## NOTICE OF DECISION & SEPA DNS

### C+G Properties New Warehouses

<b>Land Use Application Nos.:</b>	SPR-22-010 (Site Plan Review – Type 2) SEP-22-010 (SEPA)
<b>Applicant &amp; Property Owner:</b>	MCA Architects PC C/O Ted Grund 812 SW Washington St S. 800 Portland, OR 97205
<b>Site Location:</b>	1680 Howard Way
<b>Parcel &amp; Size:</b>	508340101, 68,000 SF
<b>Zoning Designation:</b>	Light Industrial, I-1
<b>Date Application Received:</b>	October 12th, 2022
<b>Notice of Application &amp; Likely DNS issued:</b>	November 3 <sup>rd</sup> , 2022 [See: case # SEP-22-010]
<b>Comment Period &amp; SEPA Appeal Period Ended:</b>	November 23 <sup>rd</sup> , 2022
<b>Notice of Decision Issued:</b>	December 1 <sup>st</sup> , 2022
<b>DRC Decision:</b>	Approve with Conditions

PRELIMINARY LANDSCAPE PLAN

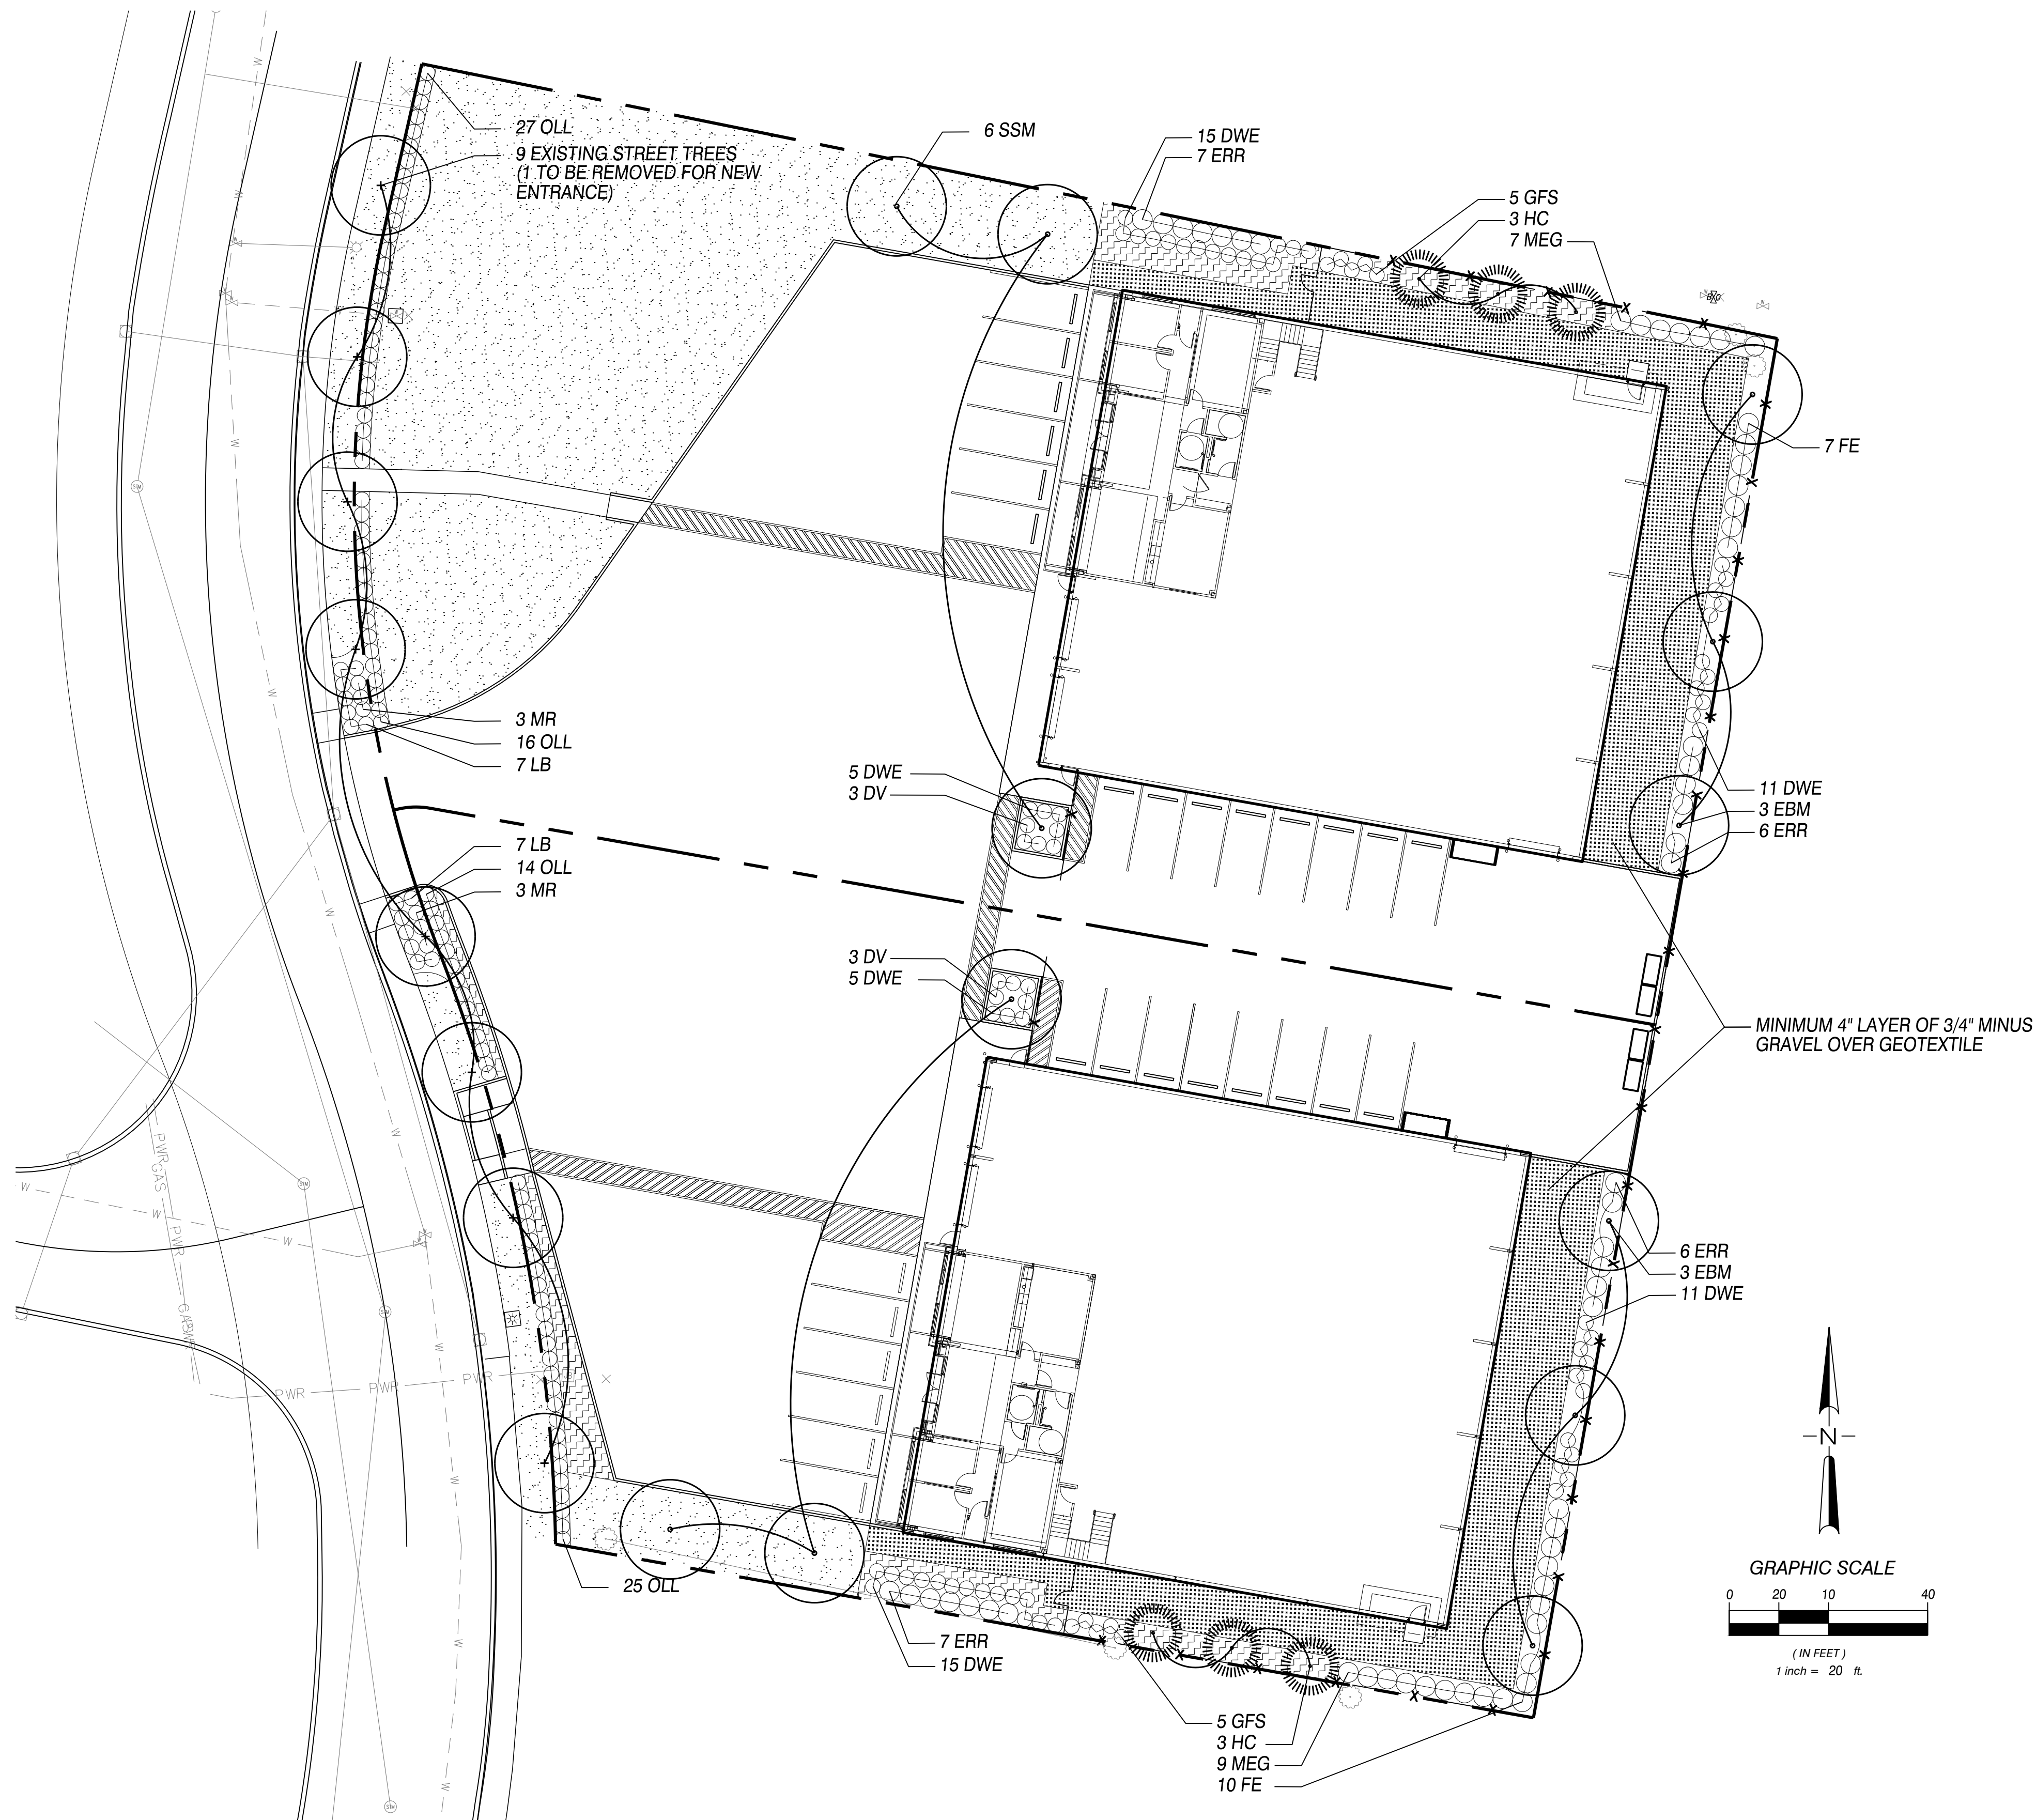
**Finding 30:** No caliper measurement is given for the Hogan Cedar plantings proposed. A condition of approval has been added that the applicant shall include caliper measurements for all proposed trees. However, staff acknowledges that available stock from nurseries can vary and strictly adhering to 2-in. caliper may be challenging. The proposed plant schedule is acceptable so long as they remain close to size requirements. *(See Condition 10.a)*

**Finding 32:** A variety of shrubs are proposed as a part of the preliminary landscaping plan. Proposed shrubs range from 3 gallon to 5 gallon in size, which does not meet the standards of WMC 17.44.135 (F). Any proposed shrubs indicated on the final landscaping plan shall be in 5-gallon or larger tubs. A condition of approval has been added that any shrubs proposed as a part of the final engineering plans must be in 5-gallon or larger tubs. *(See Condition 10.b)*

**Finding 40:** Per 17.44.136 (G), all mechanical equipment, outdoor storage and manufacturing areas, service and delivery areas, garbage receptacles and recycling containers shall be fully screened from view from all public streets and adjacent nonindustrial zoning district(s) and/or use(s) in a manner which is architecturally integrated with the structure. Such screening shall be a minimum of six feet provided by a decorative wall (i.e., masonry or similar quality material), evergreen hedge, opaque fence complying with the standards of this section, or a similar feature that provides an opaque barrier. A condition of approval has been added that proposed garbage area be identified on final site plan submitted with civil engineering review and that dimensions and elevations be provided demonstrating compliance with this standard. (*See Condition 10.c*)

- a) Provide an accurate caliper (diameter) measurement for the proposed Hogan Cedar plantings;
  - b) All shrubs proposed as a part of the final engineering plans must be in 5-gallon or larger tubs. Shrub size must be identified on the final landscaping plan; and

- c) All mechanical equipment, outdoor storage, and manufacturing areas, service areas, garbage and recycling areas shall be adequately screen per WMC 17.44.136(G). Provide updated plans identifying trash enclosure(s) and provide trash enclosure dimensions and elevations with final engineering submittal.
